DESIGN STATEMENT

2361
FORD CORK LRD

FRD_XX_XX_RP_JFA_AR_P6000
November 2024

Section 32B Meeting Response (LRD 002-24)

Typical floor plan presented at the Section 247 meeting | not to scale

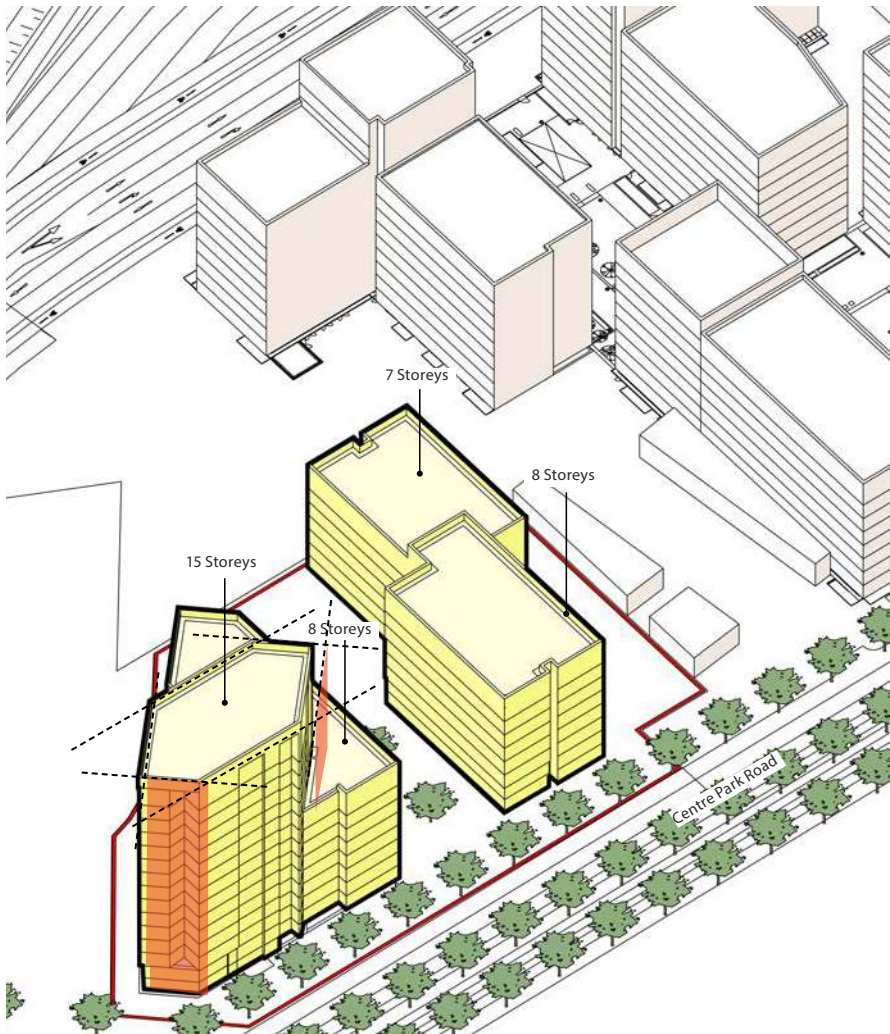
The proposed Block B tower has been reduced by 4 floors, and the lowest part of the block by 1 floor. The number of units proposed has dropped by circa 14% from 210 to 181 units.

The proposed layout has been revised to include a gym facing the main road and Street C of the adjacent scheme. Access to Block B from Centre Park Road has also been introduced, increasing the active frontage along the street.

The proposed scheme has improved its relationship with Street C thanks to the relocation of the Block A entrance and improved landscape proposal. Block A has also been moved to the west to help with its relationship with Street C in terms of scale.

Item 1 - Proposed basement plan (west section beneath Block A)

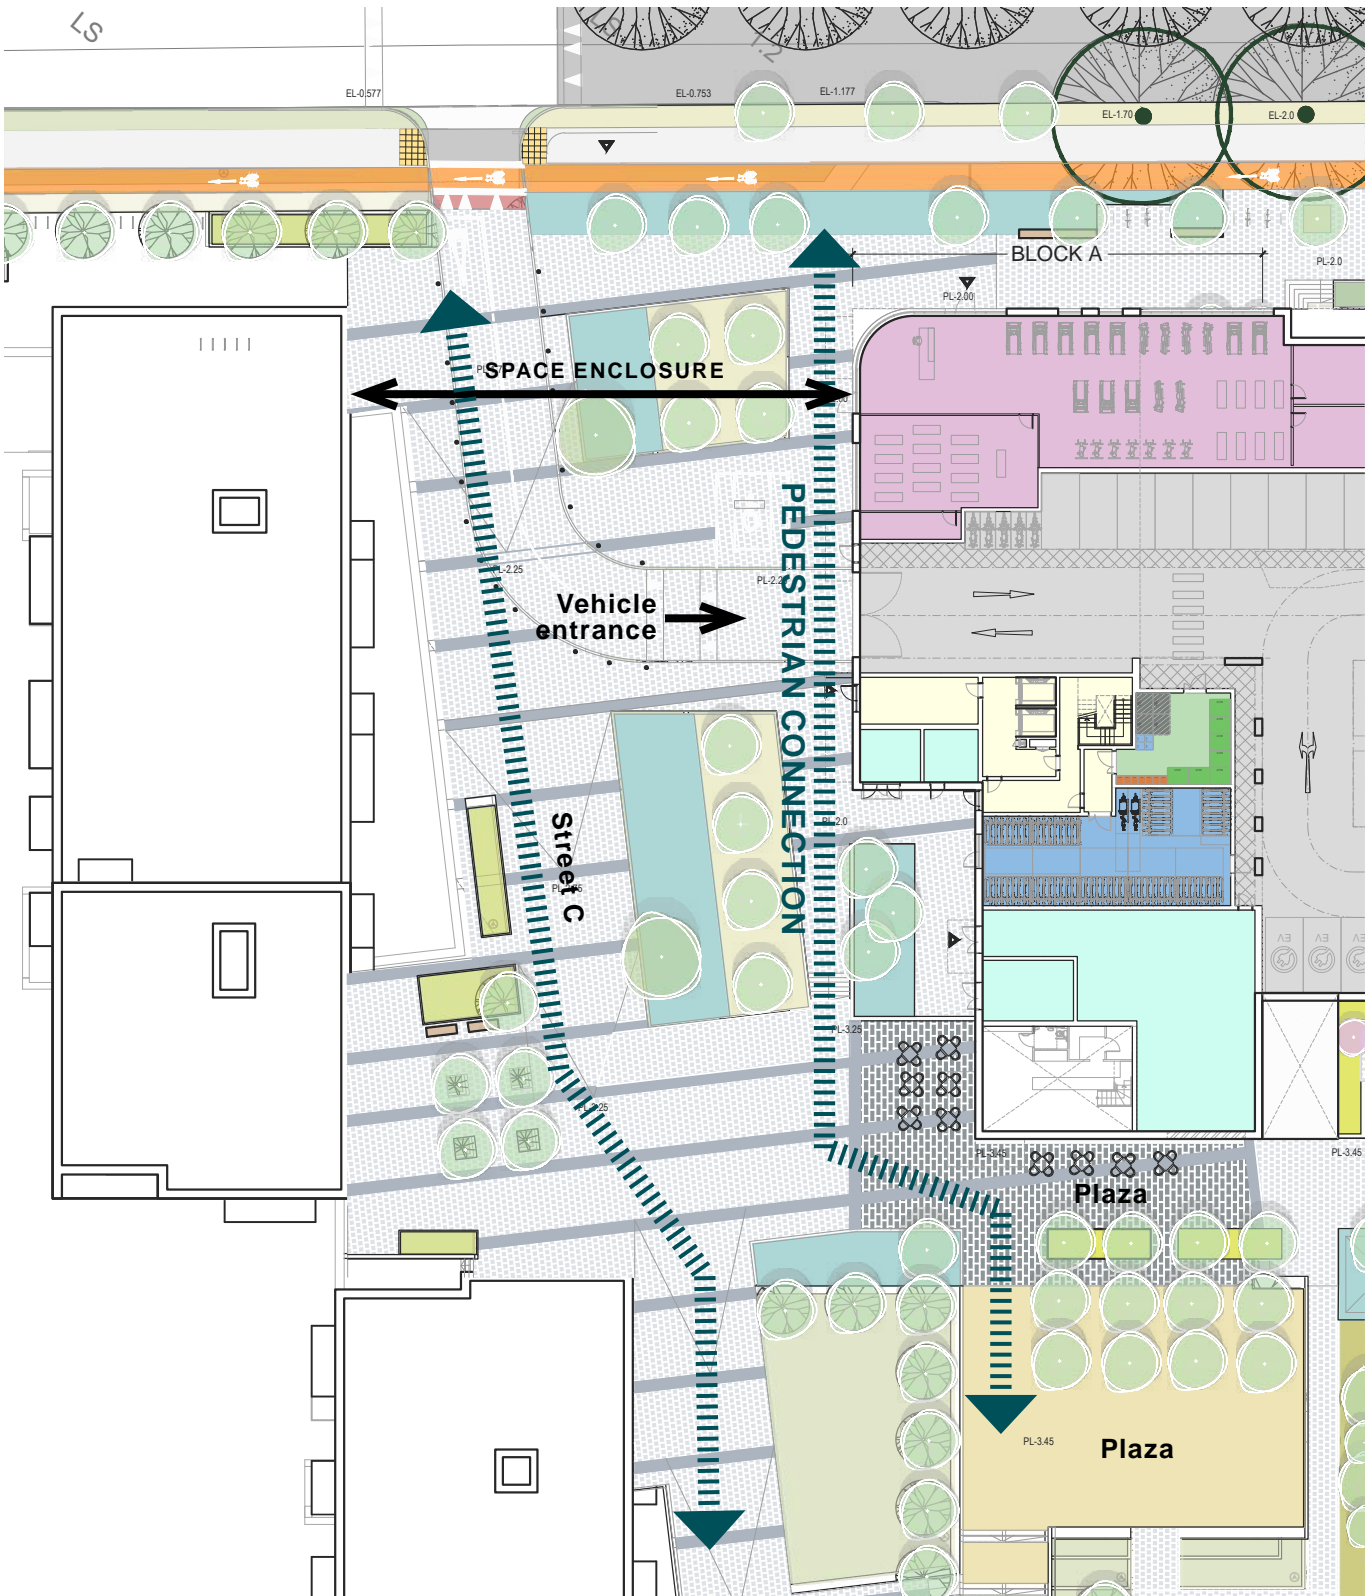
1.b. “The proposed vehicle entrance serving the undercroft car park should be relocated to Street C with the proposed disabled parking bay removed completely (all parking should be provided within the undercroft car park). The removal of this entrance, and associated roadspace, will provide an opportunity to create an enhanced public space within the development lands and remove potential conflicts along Centre Park Road.”

We have made the requested amendments, relocating the vehicle entrance for the undercroft car park to Street C and removing the associated roadspace to create an enhanced public space within the development. However, the proposed disabled parking bay has been retained, as we believe its current position does not interfere with pedestrian connections and provides convenient access, supporting the needs of the residential scheme. Care has been taken to maintain pedestrian access along Street C and reduce conflict between pedestrian, cyclists and vehicles.

Item 2.a - Block B ground floor plan

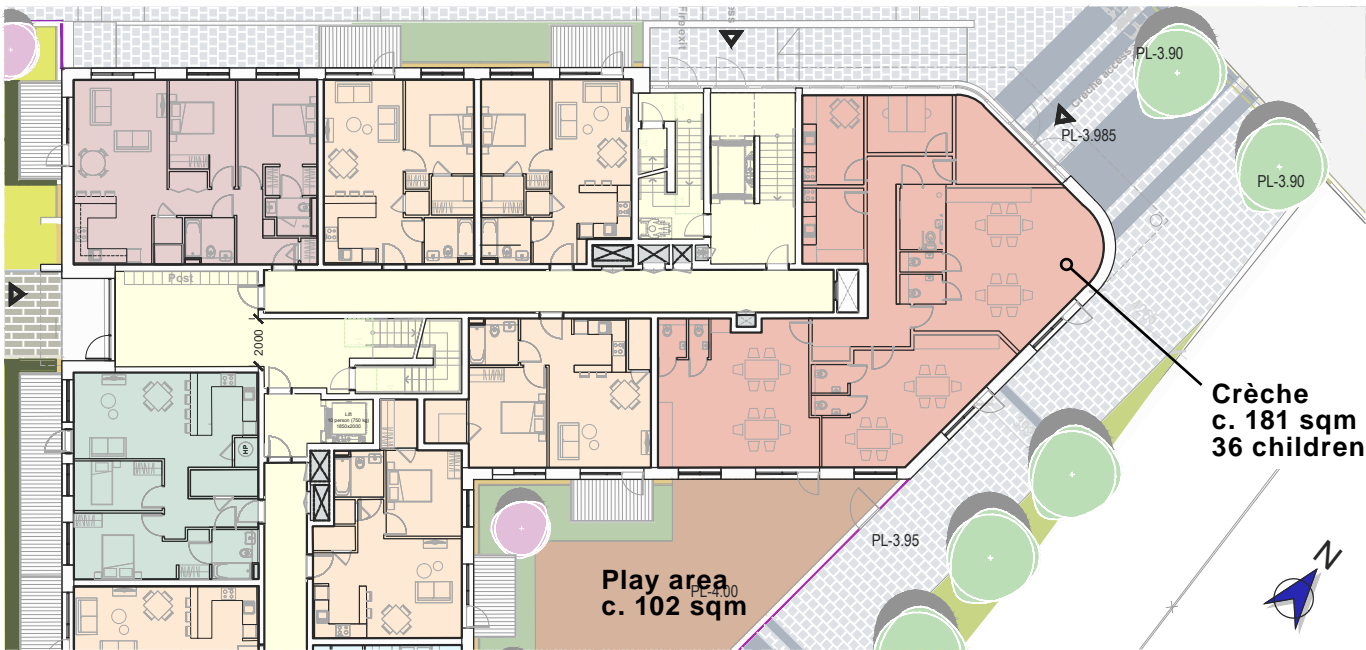
2.a. “The inclusion of a childcare facility within the proposed development. This facility should be of a capacity appropriate for the proposed development and the childcare provision demand for this location, with consideration given to ensuring the viability of such a facility.”

In response to the inclusion of a childcare facility within the proposed development, we have designed a crèche with three classrooms, providing 35 places. The facility also includes toilets, staff areas, and a kitchen. According to childcare guidelines, the required number of childcare spaces for this scheme is 30, while our proposed crèche exceeds this requirement. Additionally, there is an adjacent external play area of circa 102 square meters to the south, enhancing the facility’s functionality. We believe this design meets the needs of the development, which consists of 82 two-bedroom apartments and 32 three-bedroom apartments.

Item 2.b - Proposed cafe/retail unit plan

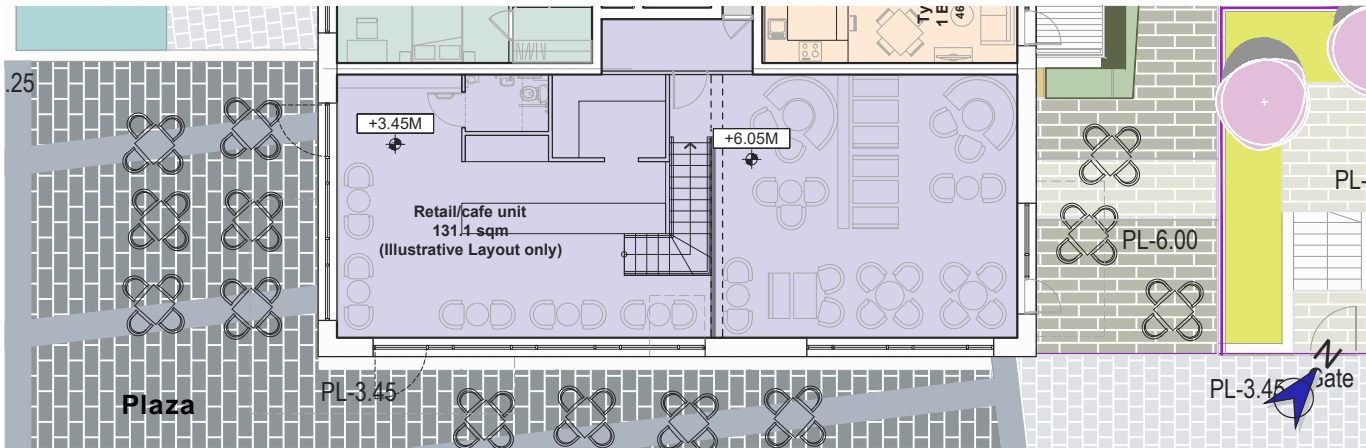
2.b. “Consideration should be given to the location of the proposed retail/café unit and to the location of the proposed childcare facility (see point a. above). The application should give consideration to locating the café/retail unit to the South of Block A so as to open onto the open space/plaza area to create an active public use for this public open space which would relate to the proposed uses in the adjacent development in this location. Consideration should be given to the position of the childcare facility within Block B with the use of the South-Eastern public open space area as the external play area.”

We have taken the council’s feedback into consideration and made adjustments accordingly. We are now proposing a café/retail unit located to the south of Block A, facing the public plaza, to create an active and engaging use for the open space, complementing the adjacent development. The café will feature a double-height space on the south corner, which enhances the openness and appeal of the area, creating a welcoming atmosphere and encouraging greater interaction with the public space. Additionally, we have positioned the crèche at the north-east end of Block B, with the external play area situated immediately to the south, ensuring convenient access and functionality.

Item 2.c - Centre Park road elevation

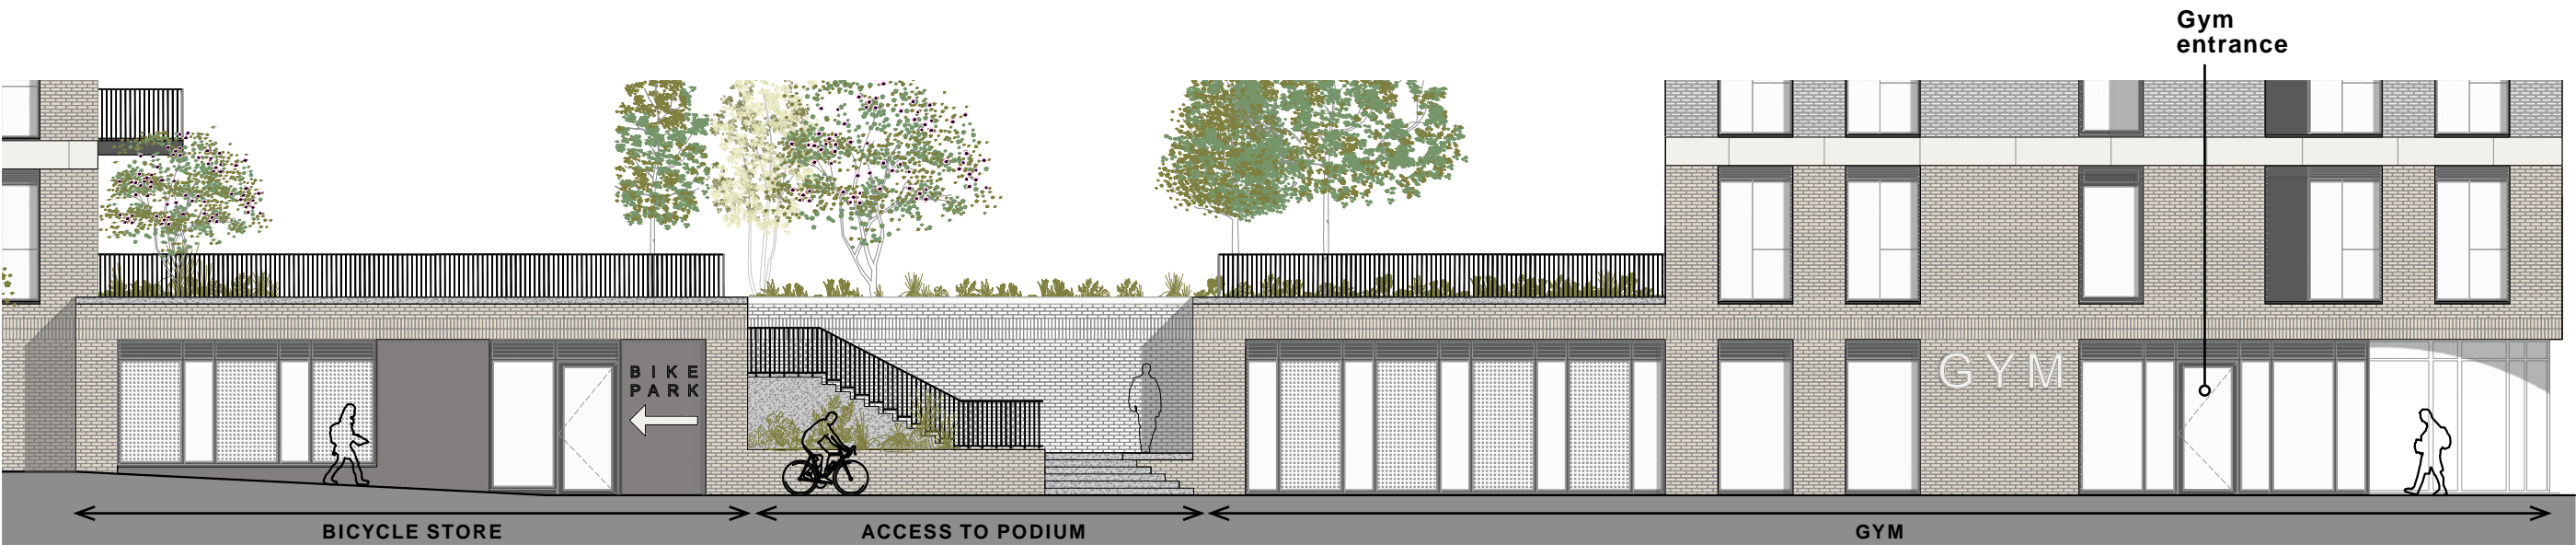
2.c. “The applicant should give further consideration to revising the Basement Plan and Ground Floor Plan to ensure more active frontages along Centre Park Road and the Street C Elevation. Consideration should be given to the positioning of the Plant, Storage and Bicycle Parking areas to increase live, active frontages.”

In response to the council’s request, we have carefully reconsidered the design of the Centre Park Road elevation. The frontage is animated with several active features, including the long gym façade, stepped access to the podium amenity space, the entrance and rhythmic windows of the bicycle parking, the entrance to Block B, and the glass wall of the crèche. Together, these elements create a dynamic and engaging streetscape. Additionally, the proposed landscaping further enhances the vitality of this path, contributing to a more active and lively frontage along Centre Park Road.

Along Street C, the façade has been activated with several key features to enhance its liveliness. These include the café on the south corner, access to the bicycle store, the main entrance to Block A, and podium access. Additionally, the vehicle and pedestrian entrances to the car park and the gym’s curtain-walled façade, which includes both the gym and class studio, further contribute to creating a dynamic and engaging frontage. These design elements, combined with those along Centre Park Road, ensure active and vibrant frontages on both sides of the development.
